## HAERSES ROAD QUARRY MODIFICATION 3

Submissions Report

Prepared by  
**Umwelt (Australia) Pty Limited**  
on behalf of  
**Dixon Sand (No. 1) Pty Limited**

Project Director: Alex Irwin  
Project Manager: Ruth Tapp  
Report No. 4607/R08  
Date: March 2020

**Table 3 – Remodelled results for maximum 24-hour average PM<sub>10</sub> and PM<sub>2.5</sub> concentrations**

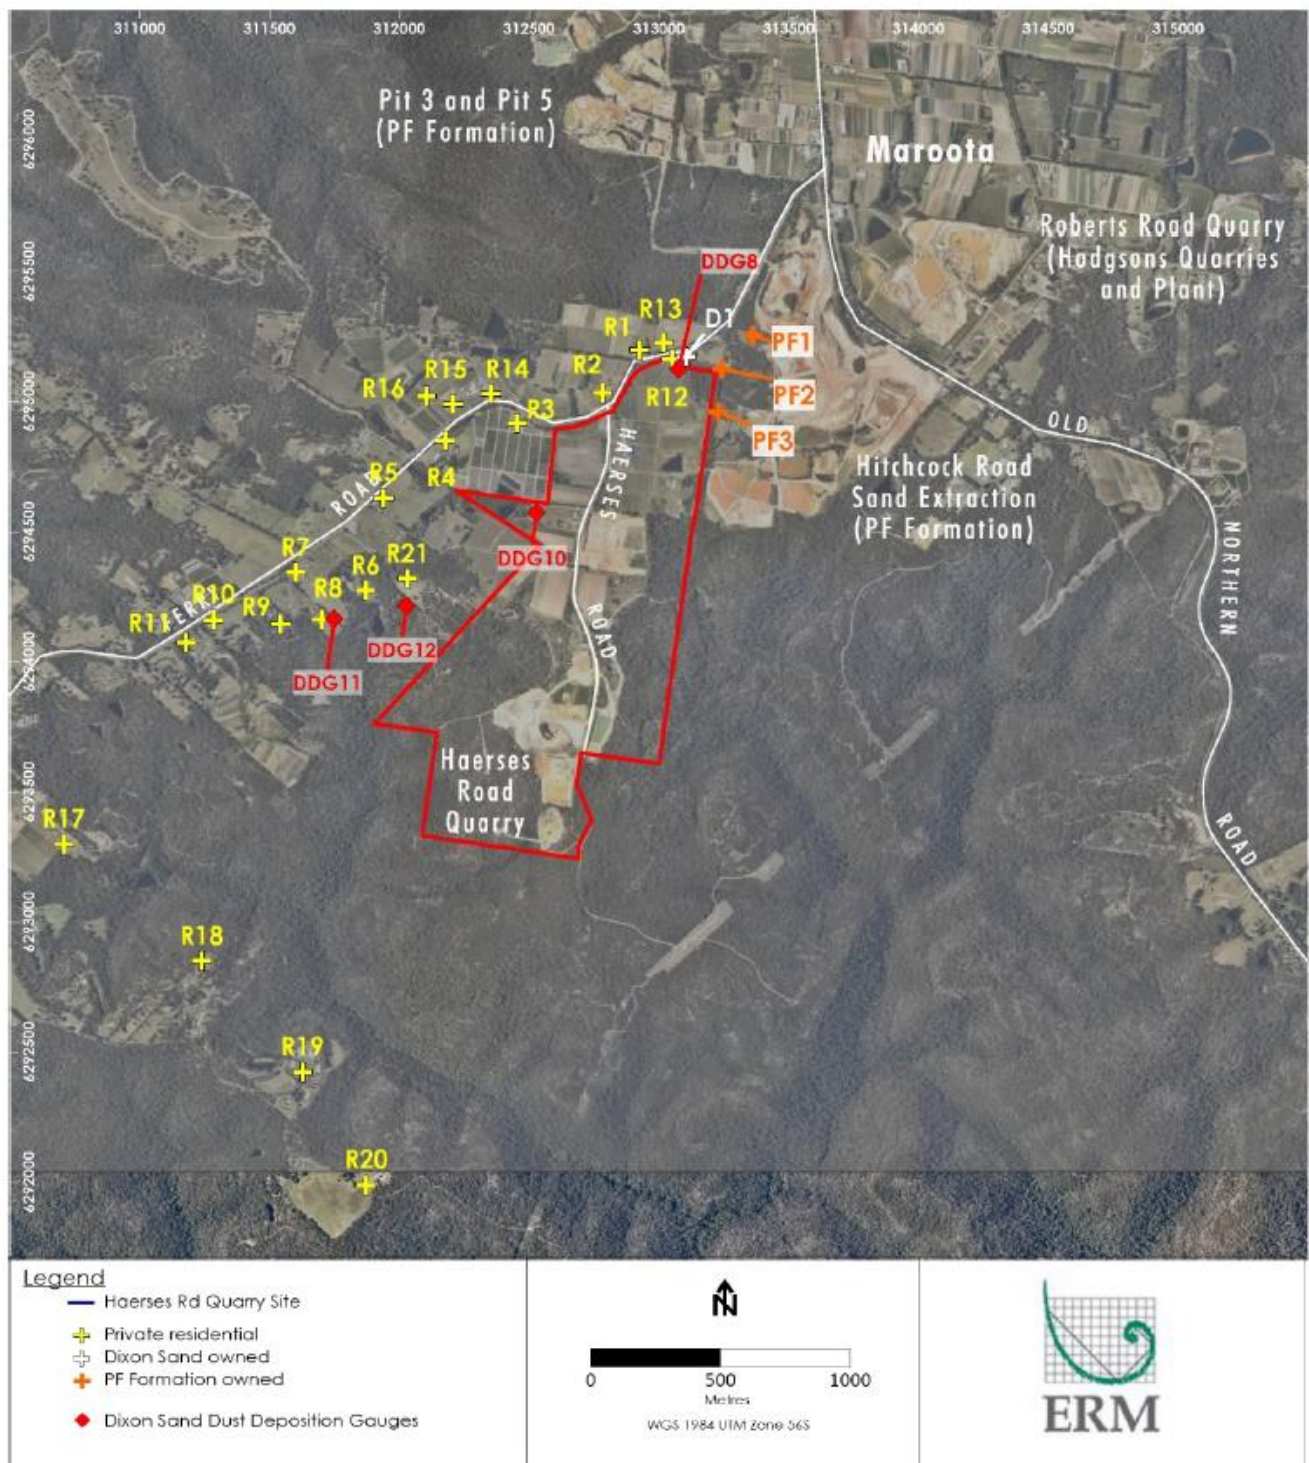
**b) The AQIA be revised to clarify discrepancies in the results presented in Table 7-2 and 7-3. In addition, all results and contour plots for all pollutants an averaging periods must be revised to confirm the predicted impacts.**

To counteract this, and for the purposes of this response, the model was re-run turning “depletion off” and assuming that all the mass remains airborne from source to receptor. This is highly conservative of course, especially for receptors further removed from the sources as there will in

reality be fallout, but it provides results that are at least in proportion. It also leads to maximum values at different receptors (further away) to those previously identified in the 2019 assessment. Table 3 presents the re-modelled results for maximum 24-hour average PM<sub>10</sub> and PM<sub>2.5</sub>. The three most impacted receptors for the maximum 24-hour average PM<sub>10</sub> results are R5, R6 and R21, which are further removed from the site (shown in Figure 1), for the reasons discussed above.

**Figure 1 – Locations of modelled receptors**

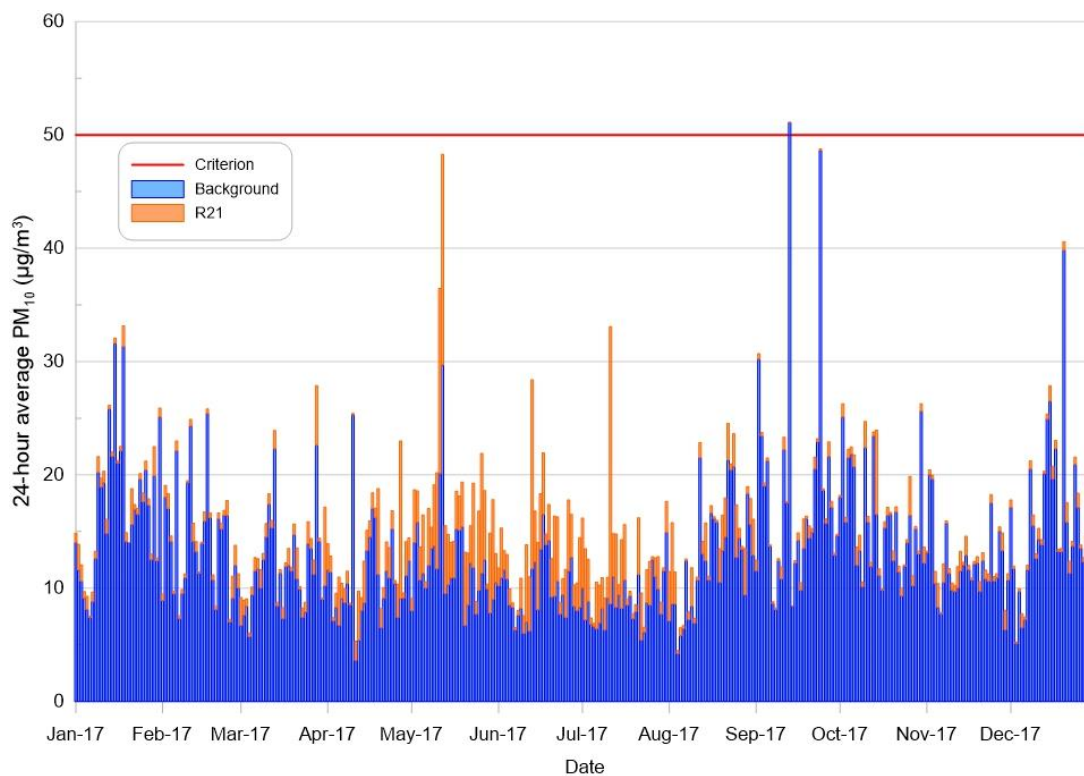
**c) The applicant should present a contemporaneous assessment for the three most impacts receptors.**

A time series plot for 24-hour average PM<sub>10</sub> concentrations showing modelled results combined with background values is shown for each of these three locations (R5, R6 and R21) in Figures 2, 3 and 4. Even with this conservative assumption of no depletion there are not predicted to be any additional exceedances of the EPA criterion of 50 µg/m<sup>3</sup> at the three most impacted receptors. Figure 5 presents the re-modelled data for PF3 (also presented in the 2019 assessment) and shows no change to the outcomes, that is, a single exceedance of the criterion over the year.

A time series plot for 24-hour average PM<sub>2.5</sub> concentrations showing modelled results combined with background values is shown for each of these three locations (R5, R6 and R7) in Figures 6, 7 and 8. Again, there are not predicted to be any additional exceedances of the EPA criterion of 25 µg/m<sup>3</sup> at these receptors.
